## **-Chapter 2 Grassroots Coalition’s Response to the Santa Monica Subbasin GSP Draft Response (Draft) continued**

### *2.1 Description of Plan Area (Draft)*

1986 Wetland Map ACOE

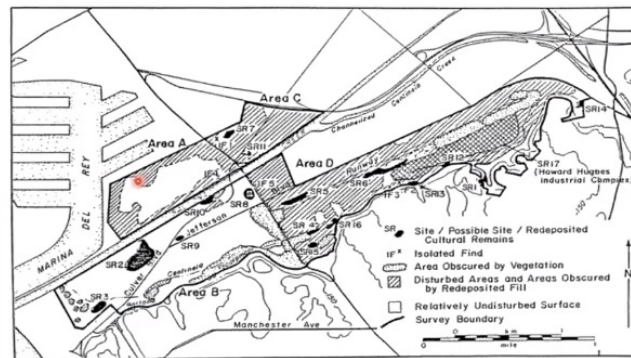
Other scientific information (Playa Vista EIR 1990 Archaeology Report; T. Huffman, USEPA ’86) also reveals that Area A maintained most of its area as undisturbed wetlands. See GSP August presentation by Dr. Margot Griswold and Grassroots Coalition, Patricia McPherson which includes mapping from the Archaeology section of Playa Vista’s EIR, 1990, and mapping of Area A performed by T. Huffman for the USEPA & Army Corps of Engineers done in 1986.

## Inconsistency of the Record of Fill Placement from Marina Del Rey

Photos to East of South Drain Area B

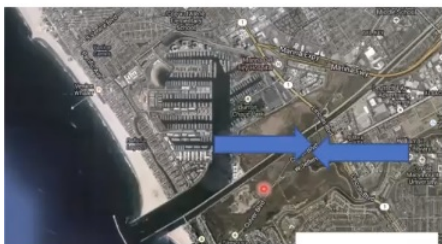
An area of actual restoration aided by litigation and Mother Nature is shown below. The large expansion of pickleweed regrowth has been due to the restoration of freshwater ponding during seasonal rains. The restored pickleweed growth is a result of Grassroots Coalition's litigation against Playa Vista and CDFW, stopping their unpermitted drainage of the wetlands that had been ongoing for 20 years. The drainage of freshwater from this region of Ballona is not mentioned in the Draft EIR. The California Coastal Commission had previously written to Playa Vista and CDFW that they were in violation of the Coastal Act, harming the hydrology of Ballona Wetlands and to end the drainage. Neither Playa Vista nor CDFW was responsive to the CCC which led to the prevailing litigation by Grassroots Coalition against Playa Vista and CDFW. The CCC, in further action, supported GC and the sealing of these drains.

FEIR has inconsistencies of existing Hydrology and Vegetation: Capping the unpermitted drains in B north resulted in native pickleweed wetland habitat.
